C L E P A

Internal dimension – Proposed requirement changes

Informal working group
Sept 2nd, 2015 SMMT, London

PROPOSED CONCEPT

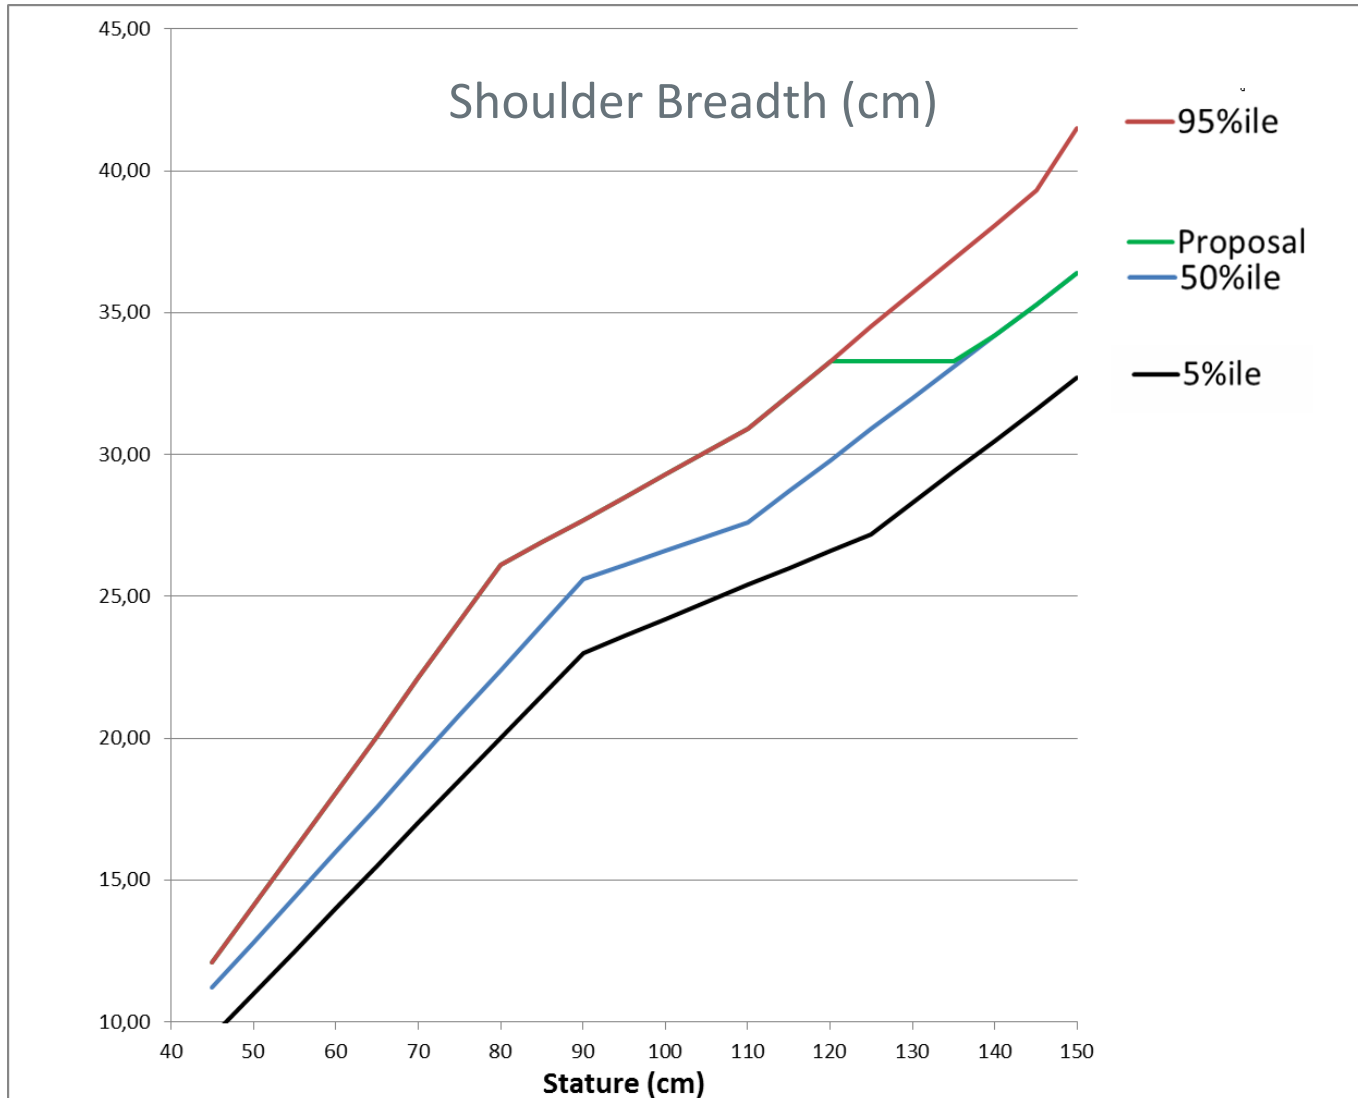
- Keep 95th centile requirements for the lower statures.

Propose adjustments for the higher statures :

- Keep 120 cm 95th centile requirement for 125, 130 and 135 cm
- Switch to 50th centile requirement above 135 cm

Proposal limited to shoulder breadth and hip breadth.

From 125 cm onwards, children can be protected by R44 booster cushions

PROPOSAL

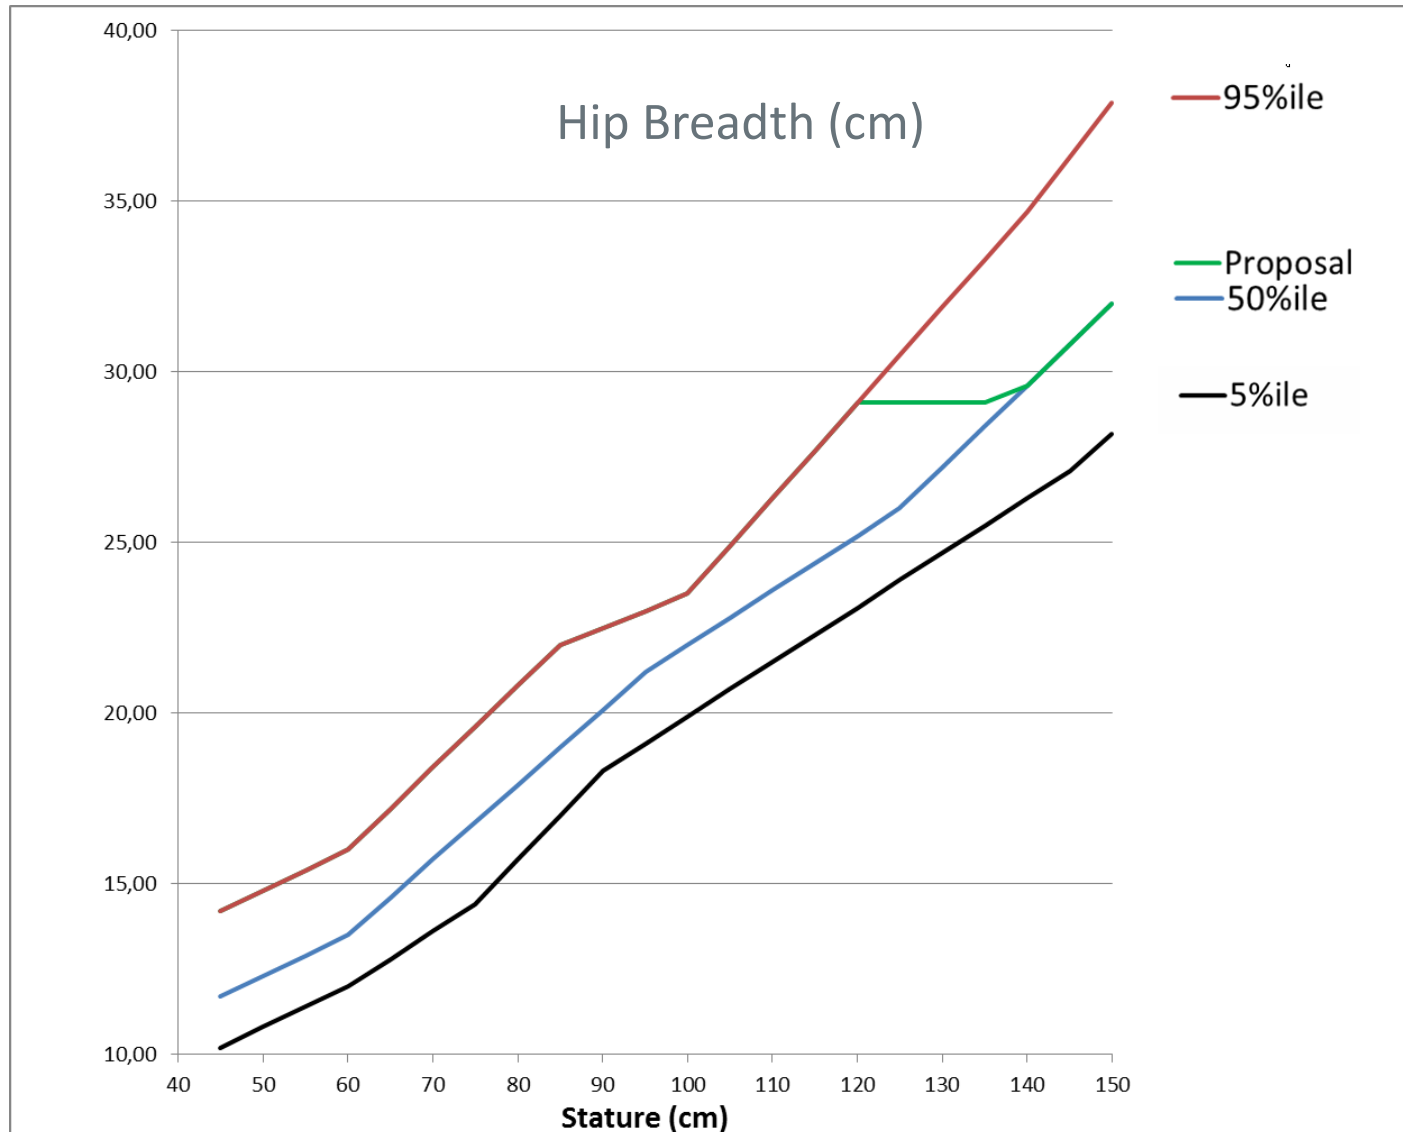
Current Requirement

<i>Stature cm</i>	<i>Minimum</i>	<i>Minimum</i>	<i>Minimum</i>	<i>Minimum</i>	<i>Minimum</i>
	<i>Sitting height cm</i>	<i>Shoulder breadth cm</i>	<i>Hip breadth cm</i>	<i>Shoulder height cm</i>	<i>Shoulder height cm</i>
A	B	C	D	E1	E2
	<i>95%ile</i>	<i>95%ile</i>	<i>95%ile</i>	<i>5%ile</i>	<i>95%ile</i>
40	NA	NA	NA	NA	NA
45	39,0	12,1	14,2	27,4	29,0
50	40,5	14,1	14,8	27,6	29,2
55	42,0	16,1	15,4	27,8	29,4
60	43,5	18,1	16,0	28,0	29,6
65	45,0	20,1	17,2	28,2	29,8
70	47,1	22,1	18,4	28,3	30,0
75	49,2	24,1	19,6	28,4	31,3
80	51,3	26,1	20,8	29,2	32,6
85	53,4	26,9	22,0	30,0	33,9
90	55,5	27,7	22,5	30,8	35,2
95	57,6	28,5	23,0	31,6	36,5
100	59,7	29,3	23,5	32,4	37,8
105	61,8	30,1	24,9	33,2	39,1
110	63,9	30,9	26,3	34,0	40,4
115	66,0	32,1	27,7	35,5	41,7
120	68,1	33,3	29,1	37,0	43,0
125	70,2	34,5	30,5	38,5	44,3
130	72,3	35,7	31,9	40,0	46,1
135	74,4	36,9	33,3	41,5	47,9
140	76,5	38,1	34,7	43,0	49,7
145	78,6	39,3	36,3	44,5	51,5
150	81,1	41,5	37,9	46,3	53,3

CURRENT R129, ANNEX 18

PROPOSAL

<i>Stature cm</i>	<i>Minimum</i>	<i>Minimum</i>	<i>Minimum</i>	<i>Minimum</i>	<i>Minimum</i>
	<i>Sitting height cm</i>	<i>Shoulder breadth cm</i>	<i>Hip breadth cm</i>	<i>Shoulder height cm</i>	<i>Shoulder height cm</i>
A	B	C	D	E1	E2
	<i>95%ile</i>	<i>95%ile</i>	<i>95%ile</i>	<i>5%ile</i>	<i>95%ile</i>
40	NA	NA	NA	NA	NA
45	39,0	12,1	14,2	27,4	29,0
50	40,5	14,1	14,8	27,6	29,2
55	42,0	16,1	15,4	27,8	29,4
60	43,5	18,1	16,0	28,0	29,6
65	45,0	20,1	17,2	28,2	29,8
70	47,1	22,1	18,4	28,3	30,0
75	49,2	24,1	19,6	28,4	31,3
80	51,3	26,1	20,8	29,2	32,6
85	53,4	26,9	22,0	30,0	33,9
90	55,5	27,7	22,5	30,8	35,2
95	57,6	28,5	23,0	31,6	36,5
100	59,7	29,3	23,5	32,4	37,8
105	61,8	30,1	24,9	33,2	39,1
110	63,9	30,9	26,3	34,0	40,4
115	66,0	32,1	27,7	35,5	41,7
120	68,1	33,3	29,1	37,0	43,0
125	70,2	33,3	29,1	38,5	44,3
130	72,3	33,3	29,1	40,0	46,1
135	74,4	33,3	29,1	41,5	47,9
140	76,5	34,2	29,6	43,0	49,7
145	78,6	35,3	30,8	44,5	51,5
150	81,1	36,4	32,0	46,3	53,3

PROPOSAL

<i>Stature cm</i>	<i>Minimum</i>	<i>Minimum</i>	<i>Minimum</i>	<i>Minimum</i>
	<i>Sitting height cm</i>	<i>Shoulder breadth cm</i>	<i>Hip breadth cm</i>	<i>Shoulder height cm</i>
<i>A</i>	<i>B</i>	<i>C</i>	<i>D</i>	<i>E1</i>
105	61,8	30,1	24,9	33,2
110	63,9	30,9	26,3	34,0
115	66,0	32,1	27,7	35,5
120	68,1	33,3	29,1	37,0
125	70,2	34,5	30,5	38,5
130	72,3	35,7	31,9	40,0
135	74,4	36,9	33,3	41,5
140	76,5	38,1	34,7	43,0
145	78,6	39,3	36,3	44,5
150	81,1	41,5	37,9	46,3

<i>Minimum</i>	<i>Minimum</i>	<i>Minimum</i>	<i>Minimum</i>
<i>Sitting height cm</i>	<i>Shoulder breadth cm</i>	<i>Hip breadth cm</i>	<i>Shoulder height cm</i>
<i>B</i>	<i>C</i>	<i>D</i>	<i>E1</i>
61,8	30,1	24,9	33,2
63,9	30,9	26,3	34,0
66,0	32,1	27,7	35,5
68,1	33,3	29,1	37,0
70,2	33,3	29,1	38,5
72,3	33,3	29,1	40,0
74,4	33,3	29,1	41,5
76,5	34,2	29,6	43,0
78,6	35,3	30,8	44,5
81,1	36,4	32,0	46,3
